CITY OF CODY
PLANNING, ZONING AND ADJUSTMENT BOARD
TUESDAY, MAY 22, 2012
CITY HALL COUNCIL CHAMBERS @ 12:00 NOON

**CITY OF CODY
PLANNING, ZONING AND ADJUSTMENT BOARD
STAFF REPORT**

MEETING DATE:	MAY 22, 2012	TYPE OF ACTION NEEDED	
AGENDA ITEM:		P&Z BOARD APPROVAL:	X
SUBJECT:	D-Rock Boyz/WY RIVER TRIPS WATER FEATURE, SPR 2012-21	RECOMMENDATION TO COUNCIL:	
PREPARED BY:	TODD STOWELL, CITY PLANNER	DISCUSSION ONLY:

MEETING DATE:	MAY 22, 2012	TYPE OF ACTION NEEDED	
AGENDA ITEM:		P&Z BOARD APPROVAL:	X
SUBJECT:	AMERICAN LEGION BASEBALL/CITY OF CODY BUILDING AT LEGION FIELD, SPR 2012-19	RECOMMENDATION TO COUNCIL:	
PREPARED BY:	TODD STOWELL, CITY PLANNER	DISCUSSION ONLY:

SIDE VIEW

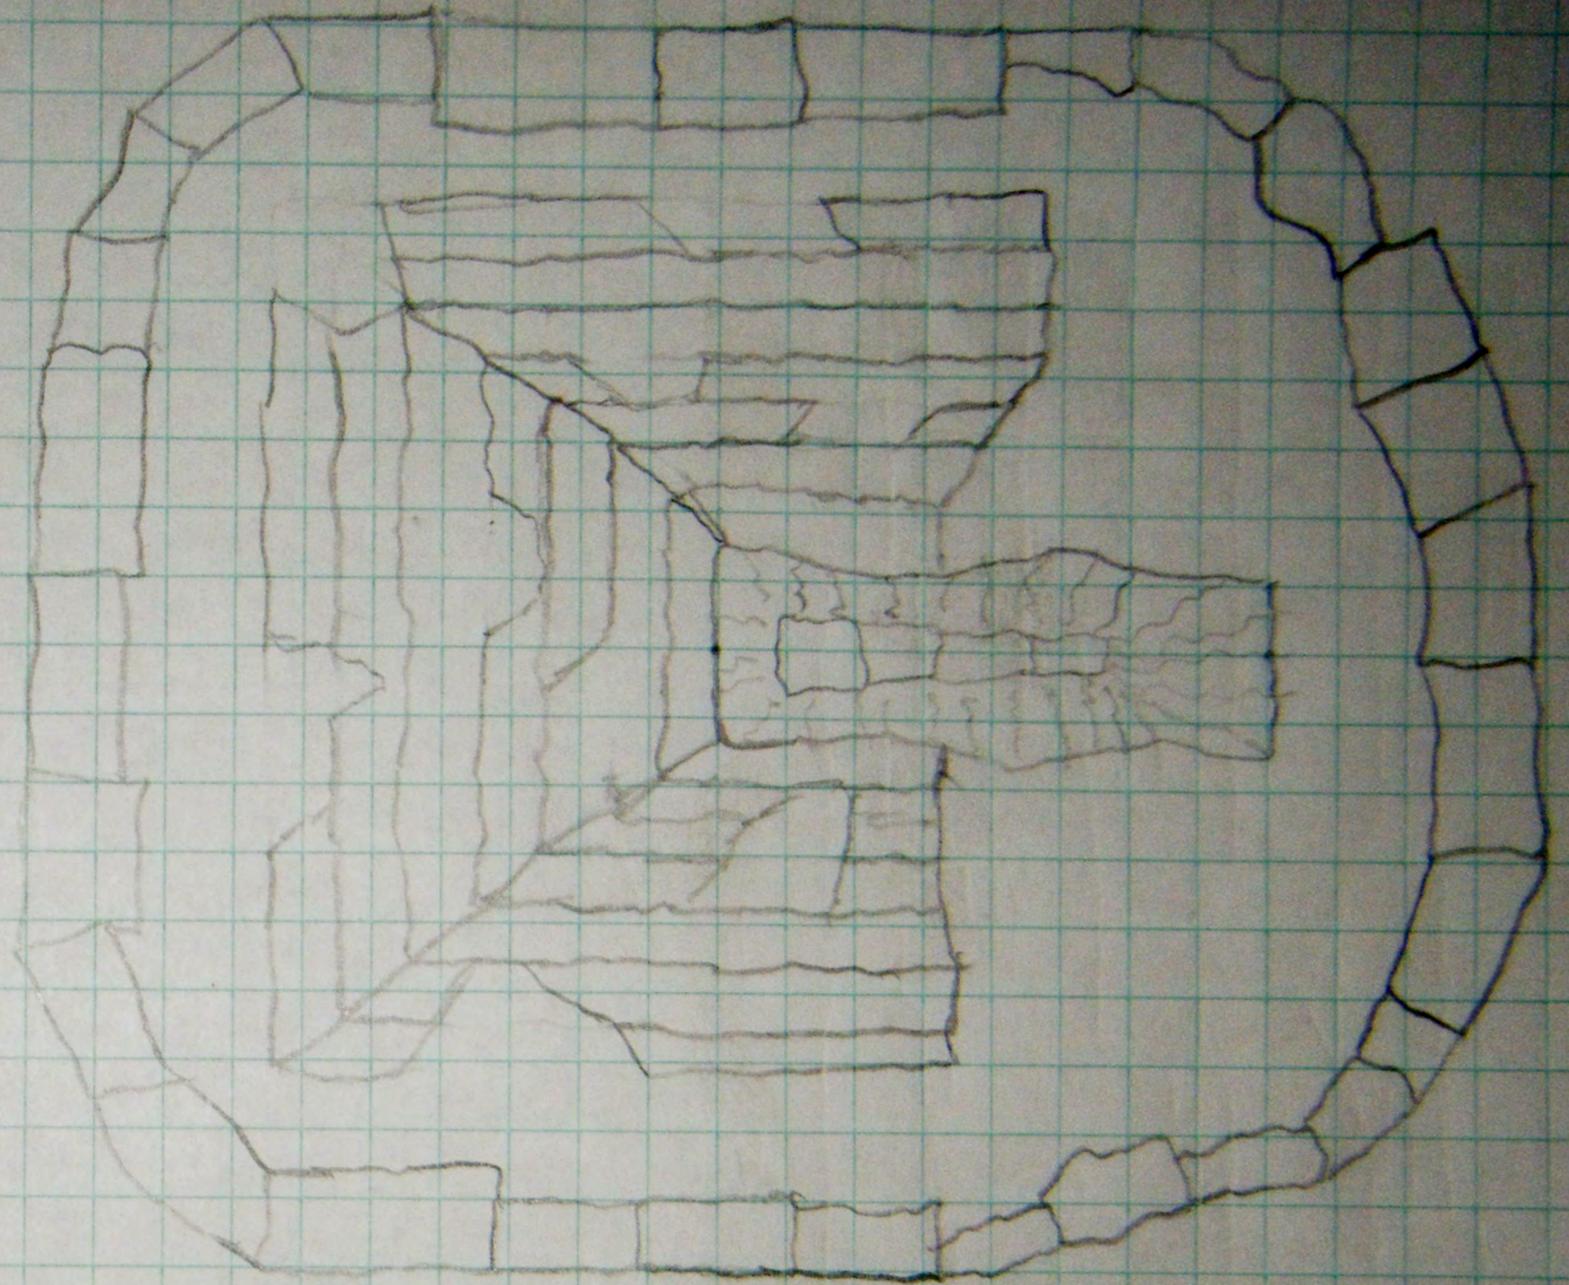
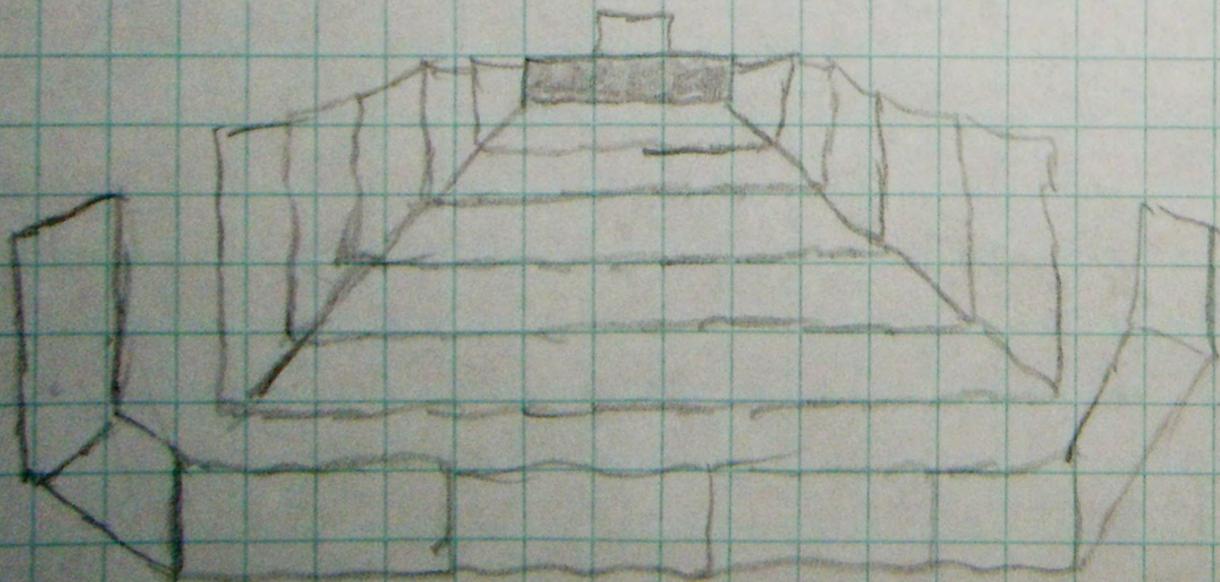
The maximum size of the water feature is 16' by 16', and 6½ feet tall. Actual size depends on available rock. A concept drawing and photo rendering is attached. The location of the water feature would be in a currently unutilized area in the southeast corner of the property, approximately eight feet back from the sidewalk. Power would be split off of the neighboring billboard and run to the water feature.

The site plan conditions that were reviewed include potential conflicts with existing utilities and easements, impacts to parking and landscaping, sign size and lighting, and maintenance of sight distance.

Staff has researched recorded documents and found no easements that conflict with the proposed location. The property owner has already called for utility locates, and no public lines were identified in the work area.

The proposal will not affect any existing parking, access, or landscaping. In fact, the sign and waterfall is primarily a landscape feature.

With the proposed sign, the property is still well below the amount of freestanding signage allowed by the current sign code. Lighting of the sign will be from up lit landscape lights. One or more lights will be directly under the sign lettering and point straight up. Another will be on the inside of the rock bench that forms the perimeter of the feature, and shine upward at an angle, into the waterfall. The other will be interior to the north portion of the rock feature and shine up into the water fountain. Light colors may change to be seasonal.

Approve the proposed water feature and sign as proposed. A building permit will be needed.

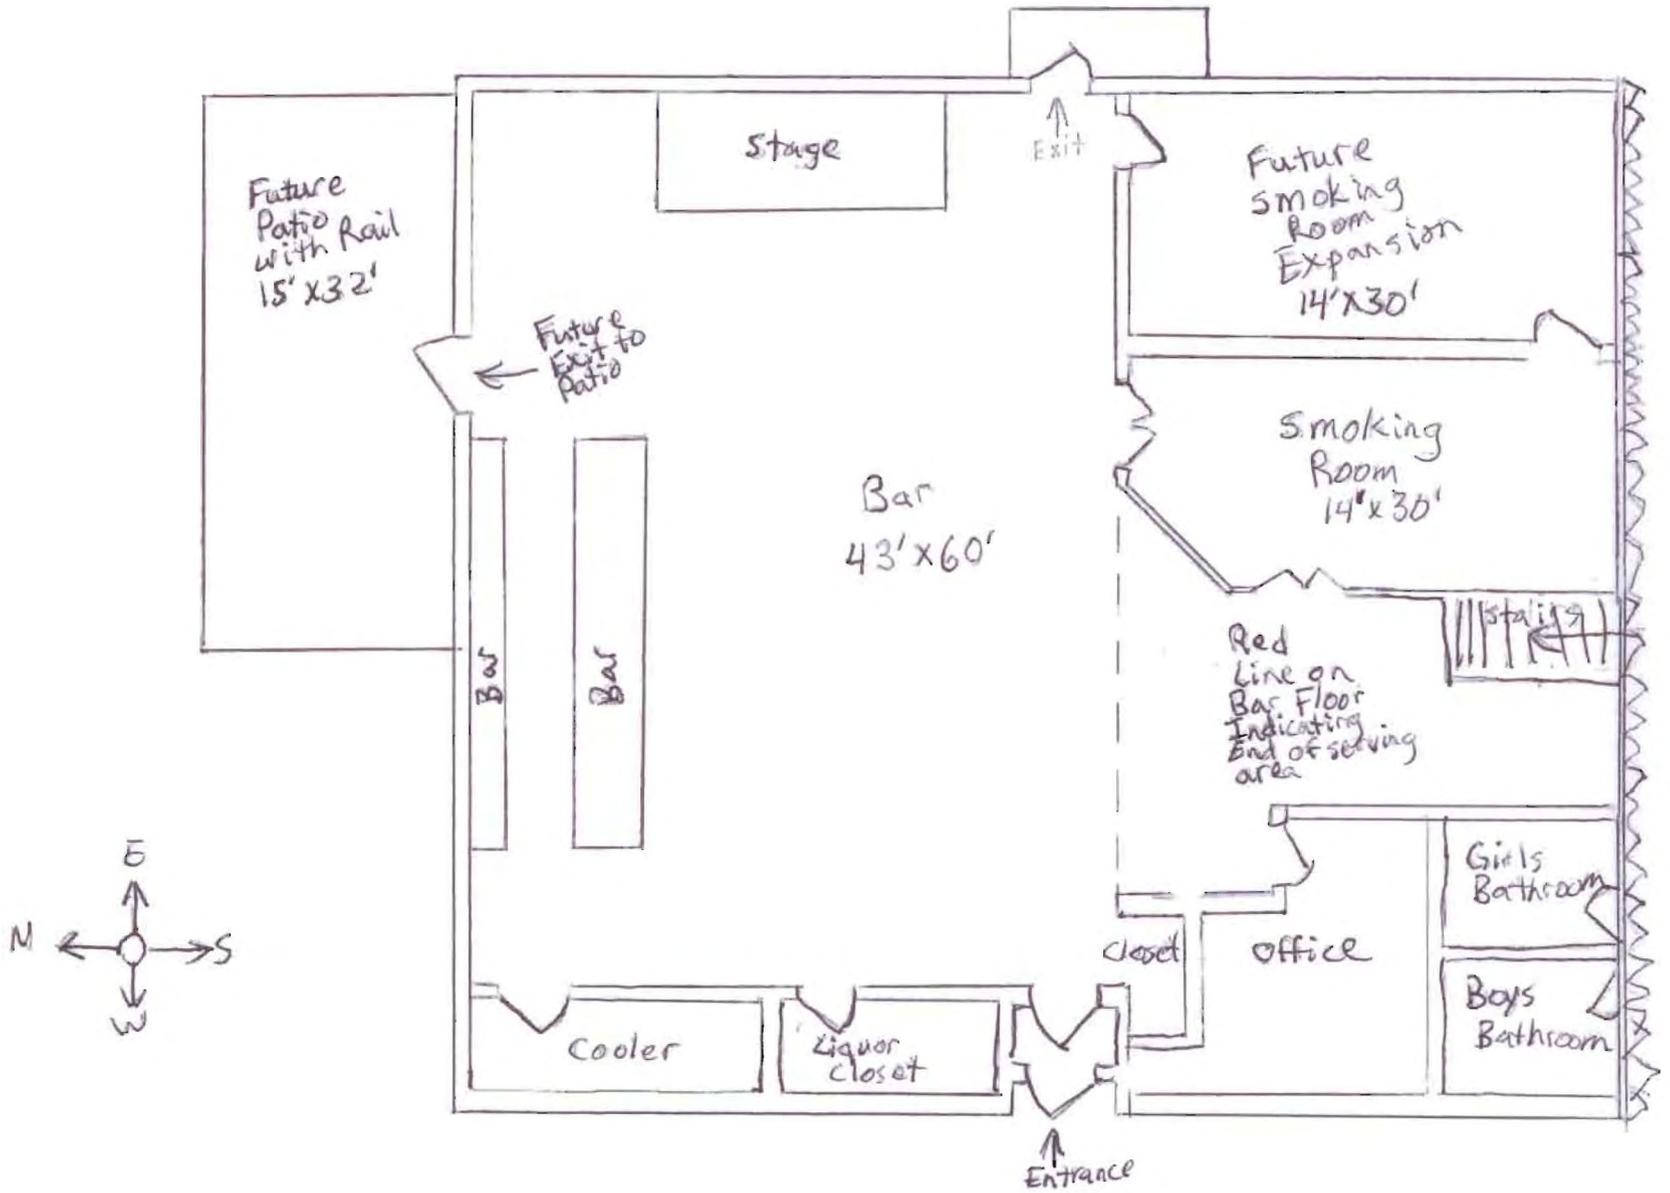
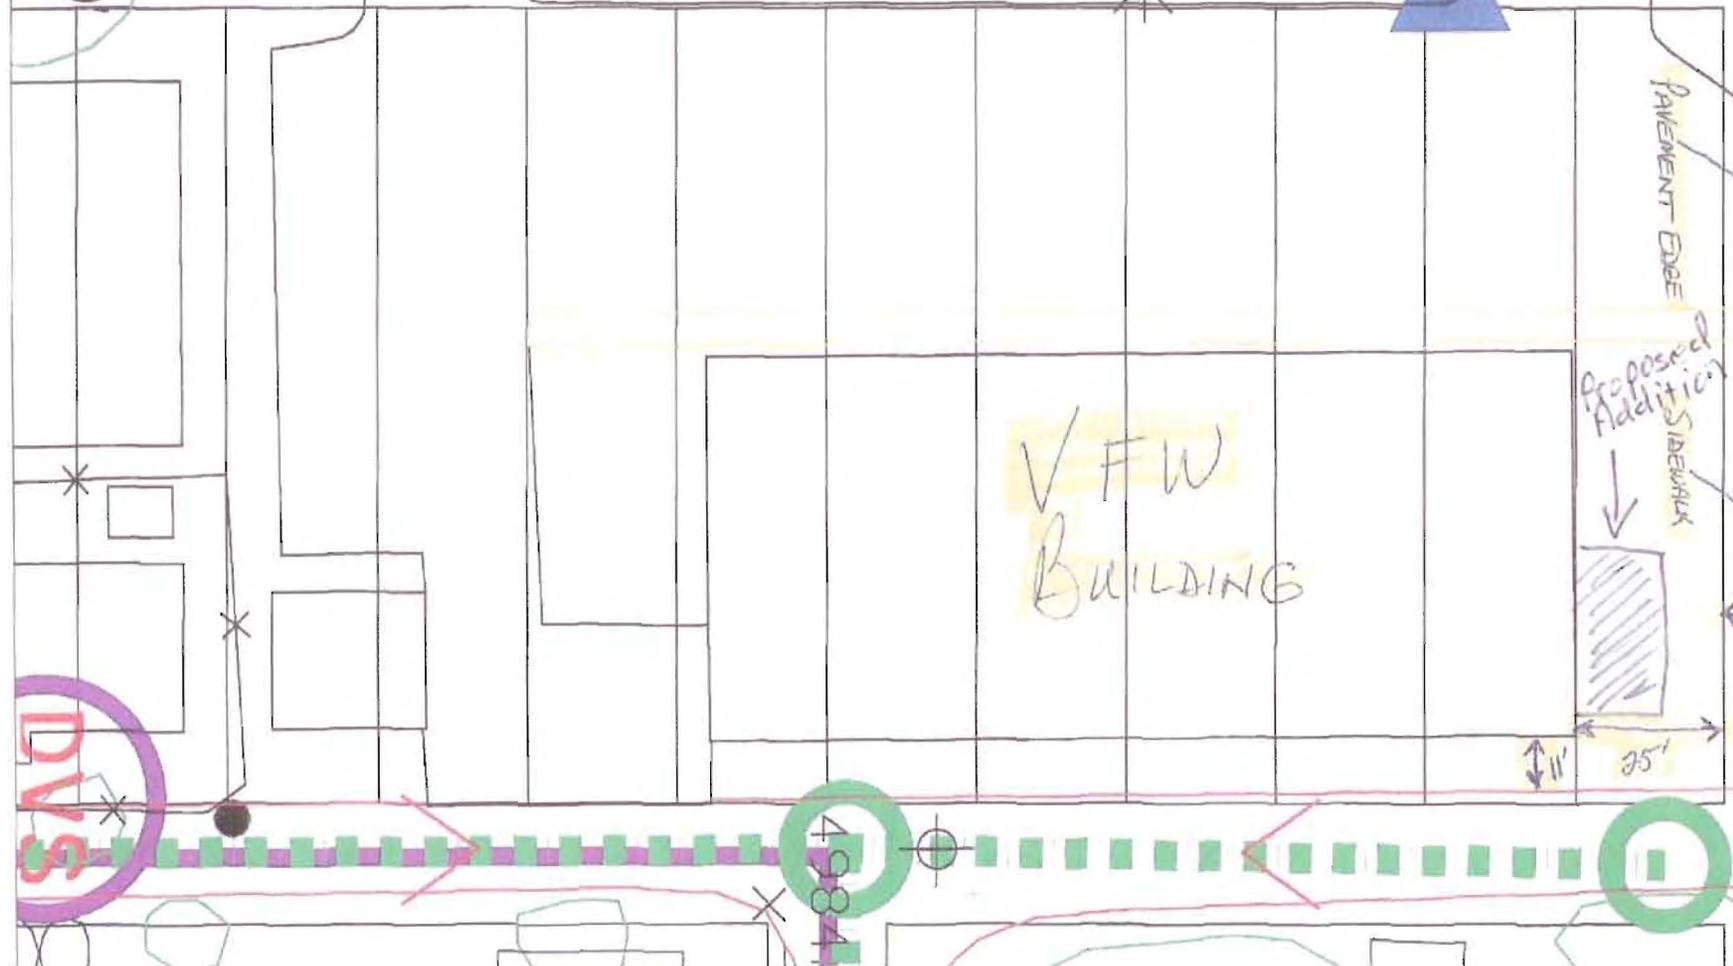
The intent of the addition is to serve as a "smoking area" for the facility, allowing the rest of the building to go "smoke free". A modification to the liquor license will be considered by the City Council, to allow the area to also be a liquor serving area. A site plan and drawing of the addition are attached. The site plan and drawings are not entirely consistent in dimensions and location. The addition would actually be inset about two feet from the east side of the building, so that the stucco quoins on the northeast corner of the building can remain. The correct width of the proposed addition is approximately 28 feet, not 32 feet as shown on the floor plan.

No storm water plan has been submitted at this time. The existing storm water plan for the facility has a drain pit just north of the proposed addition, which the addition may also be able to utilize. It is proposed that the official storm water plan (engineer calculations) not be required until such time as the patio would be enclosed. The timing of submittal is acceptable to staff, as it is technically the building that triggers the review, not the installation of a concrete slab.

No exterior lighting is proposed on the plan. If lighting is provided, it should be required to be the downward/cutoff style.

The fire marshal has indicated that the enclosed addition will require alterations and additions to the existing fire sprinkler system. The plans must be submitted for review and approval by the fire marshal.

1. Approval of the site plan is subject to City Council approval of the parking variance.
2. A storm water and grading plan meeting City storm water policy must be submitted for review and approval with the building permit for the enclosed structure. Installation of the storm water control will need to be inspected and certified by the engineer, in writing, that it was built as designed.
3. The project must otherwise comply with the submitted site plan and applicable building, fire, and electrical codes, including fire sprinkler requirements. A building permit application is required.
4. The project must be completed by May 30, 2015, or Planning and Zoning Board approval of any uncompleted construction will expire.
